*Ken Crawford
Retired Hydrogeologist
Former Principal Consultant
KLC Environmental Pty Ltd
October 2018*

Crawford Submission against the Vickery Extension Project

Vickery Extension Project Environmental Impact Statement Including Appendix C Flood Assessment

Figure 1 shows the extent of the Namoi floodplain between Carroll and Boggabri. Figure 1 Floodplain shown in red ie landslope less than 2% Image credit: Webb, McKeown & Associates Pty Ltd 2005

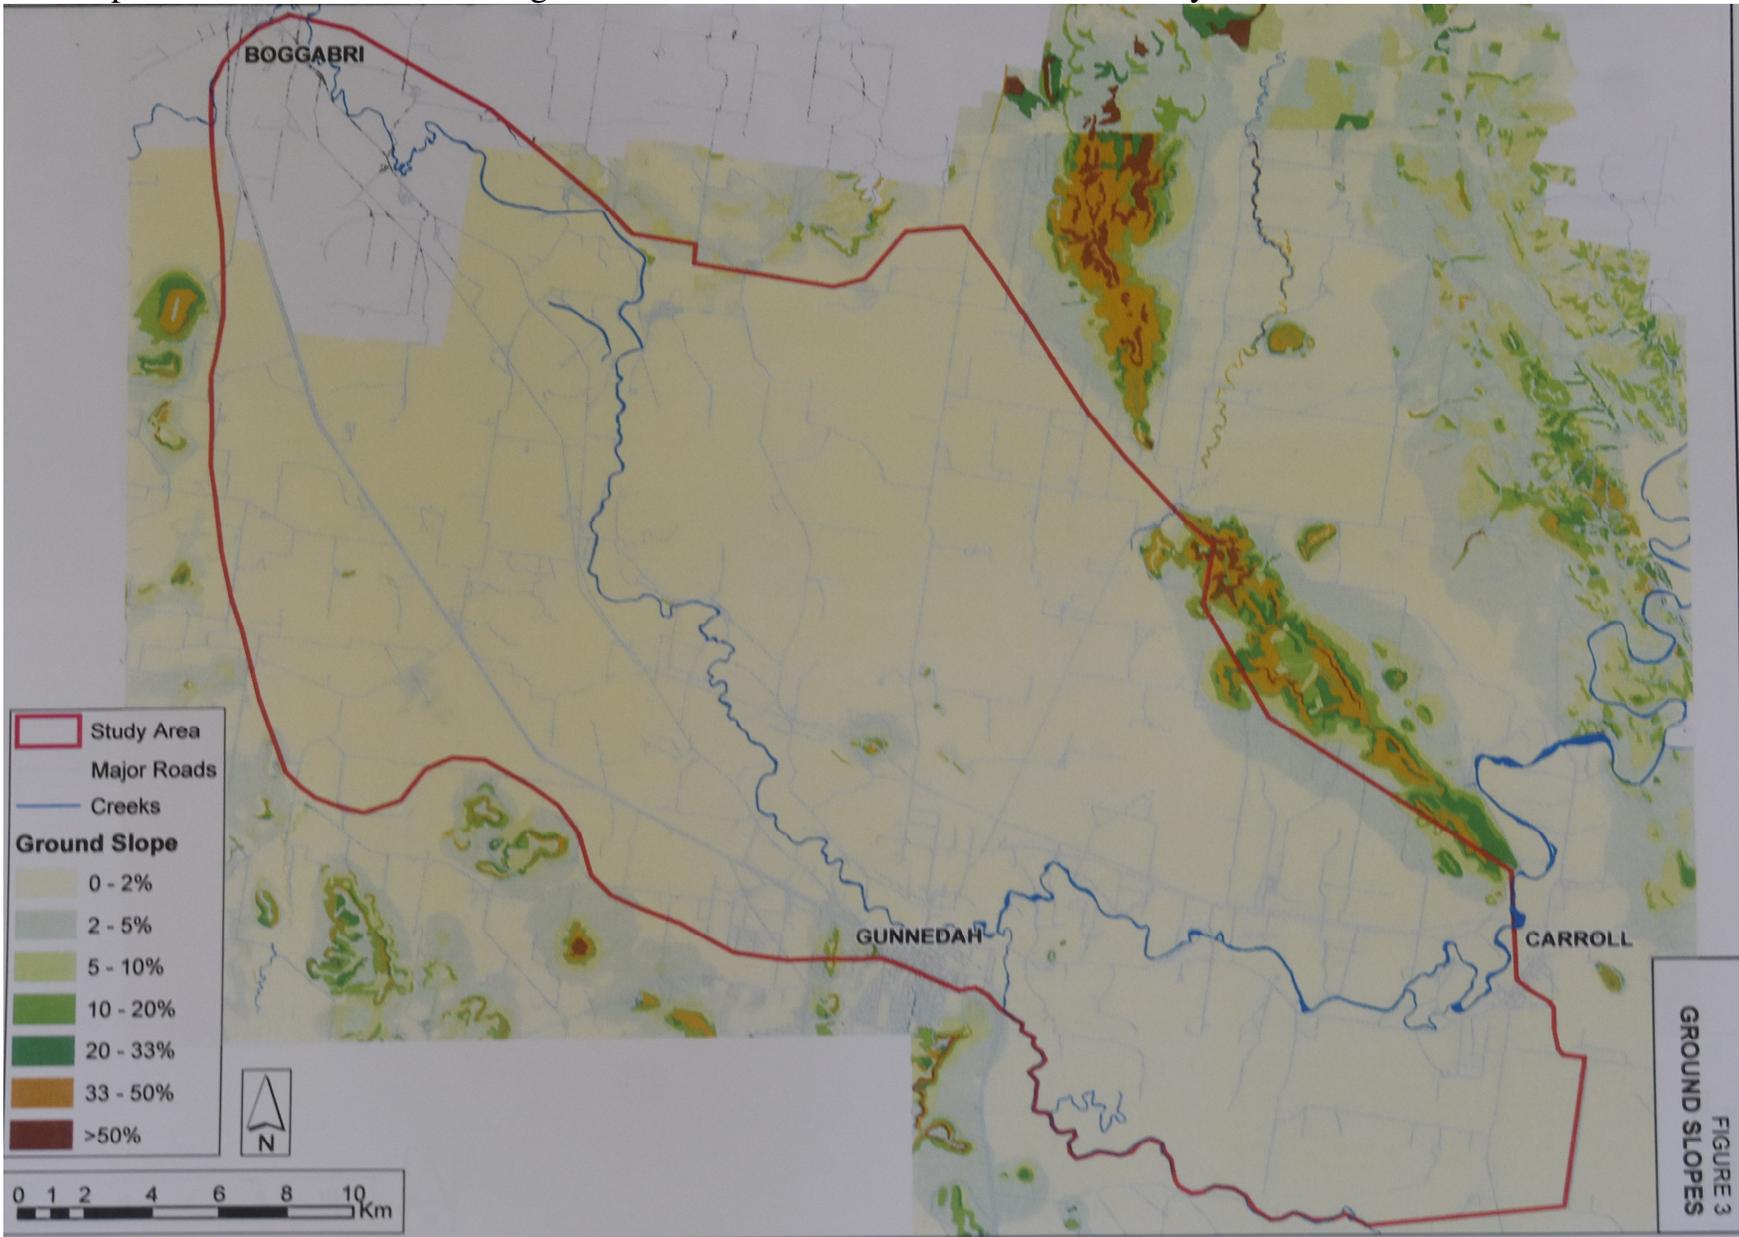
Coming back to the study area, we know from eye witness accounts that the floodway covers most of the floodplain in this area. This is confirmed by the Airborne Laser Survey (ALS) with 'draped over' hydraulic model representation of flood water depth (Webb, McKeown & Associates, 2005). see Figure 2

The above flood records demonstrate that we must remain aware of what has happened in the past. We should also not rule out more extreme events in the future. In our relatively narrow floodway, with constricting ridges both sides, in extreme floods there is nowhere else for the water to go but to increase in depth and velocity. The safer strategy is to choose alternative access routes and keep off the floodplain.

Figure 2 Airborne Laser Survey (ALS) representing depth of flooding: from Carroll-Boggabri Floodplain Management Study

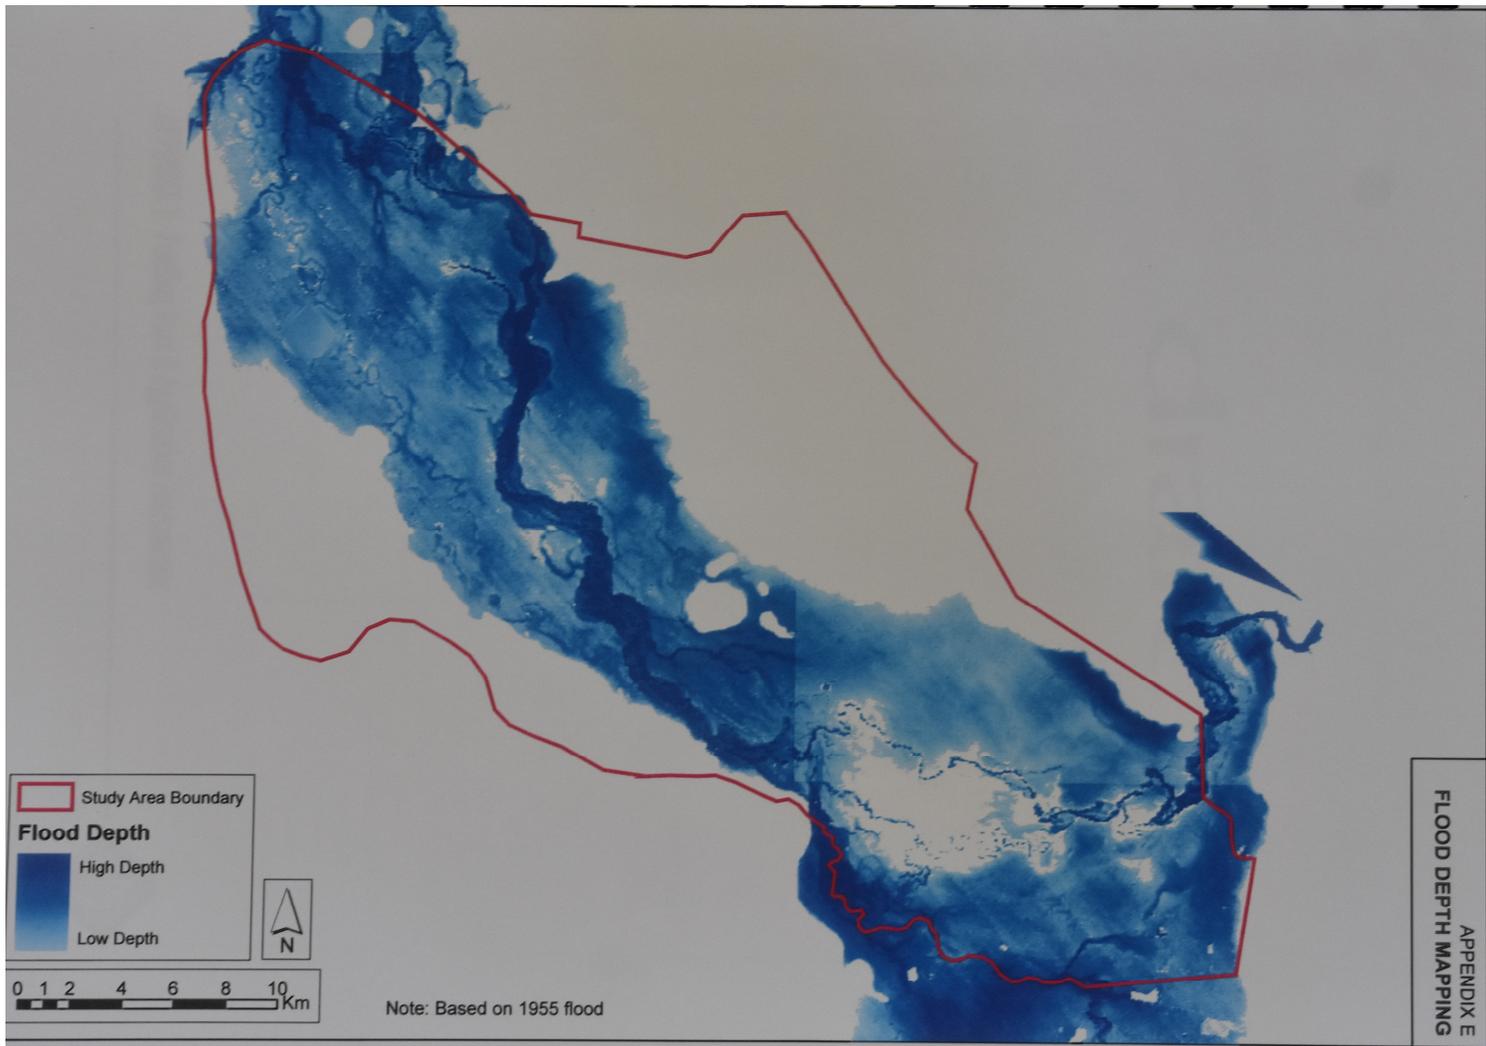
According to Webb, McKeown & Associates (2005), 'The Airborne Laser Survey (ALS) was also utilized as part of this study. The flood level results obtained from the hydraulic model were "draped" over the digital terrain model produced by the survey data to obtain a representation of the depth of flooding across the study area'. See Figure 2.

The implications of engineering structures across the floodplain include: potential erosive flooding causing soil erosion and reducing groundwater recharge, increasing stream bank erosion and ecological disconnection between river and floodplain.

Figure 1 Emerald Hill geological cross section Boggabri Irrigators Association/DLWC Regional Groundwater Review- Central Namoi Valley PPK Source of diagram Department of Water Resources (1991)

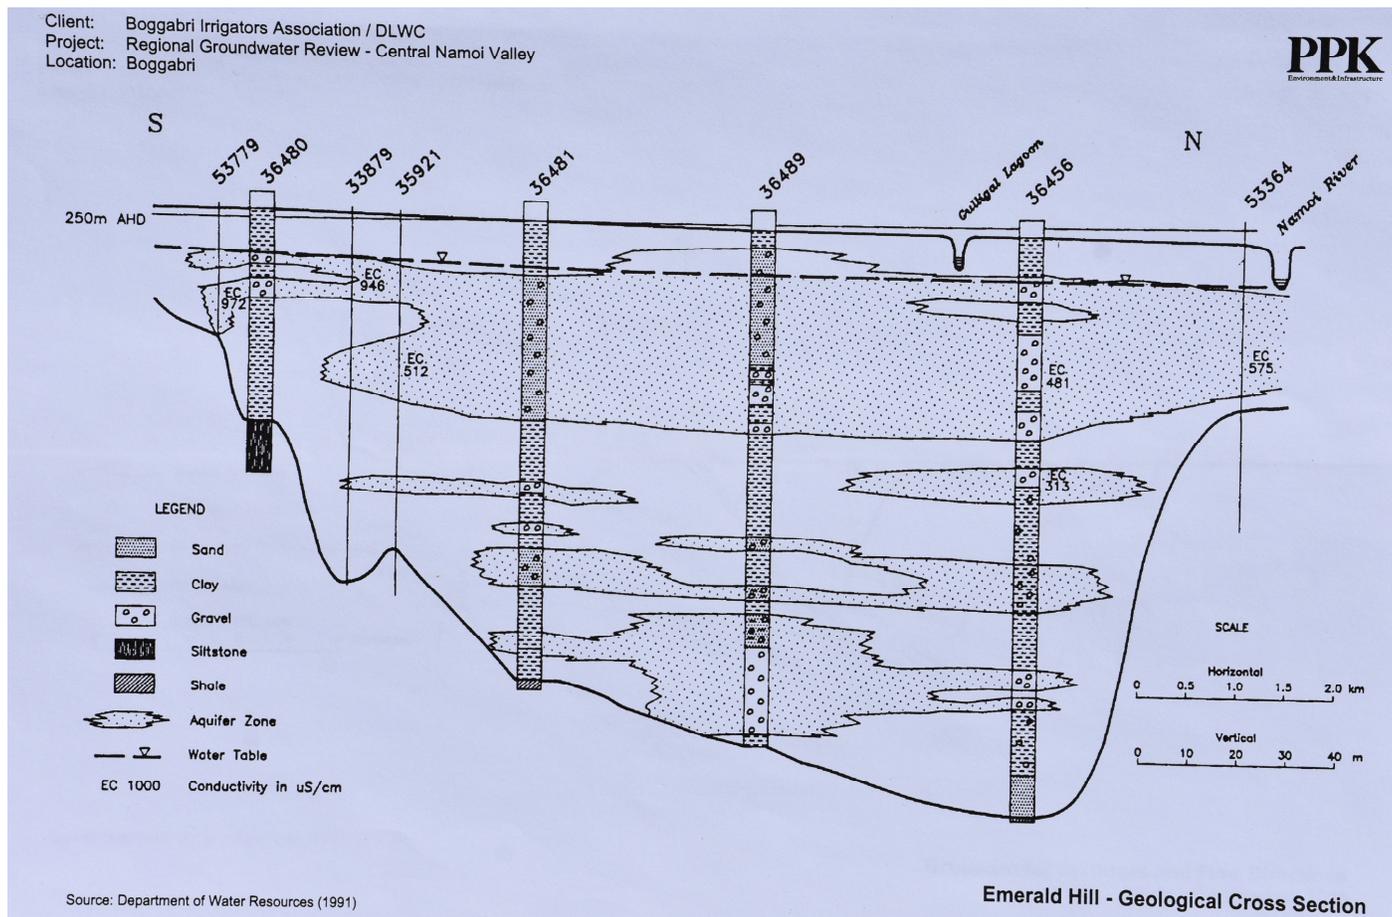
Compaction and subsidence results from, not only the initial pile driving of piers, but the long term continual vibration of heavy coal trains on the structure. The unconsolidated sediments of the alluvial aquifers in this area consist of the Narrabri Formation and the Gunnedah Formation. Gravels, sands and clay aquitards containing precious groundwater exist in this hidden valley Figure 1: Geological cross-section Emerald Hill to Namoi River.

The pore space containing the precious groundwater varies from approximately 60-65% by volume in the Gunnedah formation. These aquifers can be interfered with by way of reducing recharge and reducing the storage capacity of the pore space in the unconsolidated alluvial sediments. It happens imperceptibly over time. The continual vibration causes a ‘preferred orientation’ of the sediments. They take up less space meaning that aquifers may not refill to the same extent. Aquifer storage capacity is reduced. This a high risk to GW Zone 4 west which the proposed railway-loop divides in two.
